Piper Aircraft Corporation
Vero Beach, Florida, U.S.A.

SERVICE No. 779B BULLETIN

(Service Bulletin No. 779B supersedes and voids Service Bulletin No. 779A, dated July 16, 1984.)

SUBJECT: Landing Gear Upper Bearing Retaining Pin Replacement and Strut Assembly Inspection.

SKETCH "A"

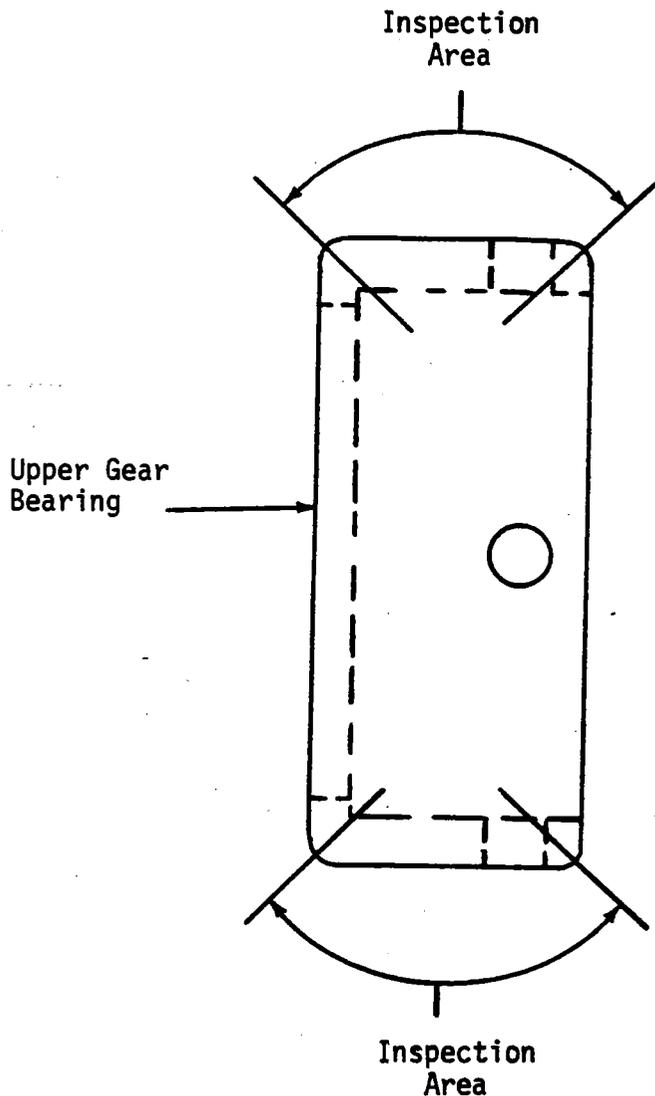
Remove the upper bearing and inspect the area shown in Sketch A. If ridges are found in the designated inspection area, replace the bearing. Any replacement bearing should also be inspected per Sketch A prior to installation.

Note: For All PA-31/31T/31P Series Aircraft, Upper Main Gear Bearing, Piper Part Number 40247-00 and/or Upper Nose Gear Bearing, Piper Part Number 31779-00. Inspection Area Must Be Chrome Plated And Have a Smooth Surface (No Ridges Allowed) Between Indicated Points on Entire Outside Surface.

For All PA-42 Cheyenne III Aircraft, Upper Main Gear Bearing, Piper Part Number 57470-02 and/or Upper Nose Gear Bearing, Piper Part Number 31779-02 are Manufactured of Bronze Alloy And Are Not Plated. Inspection Area Should Have a Smooth Surface (No Ridges Allowed) Between Indicated Points on Entire Outside Surface.

REASON FOR REVISION: To add PART II, correct Material Required, and Revise Sketch.
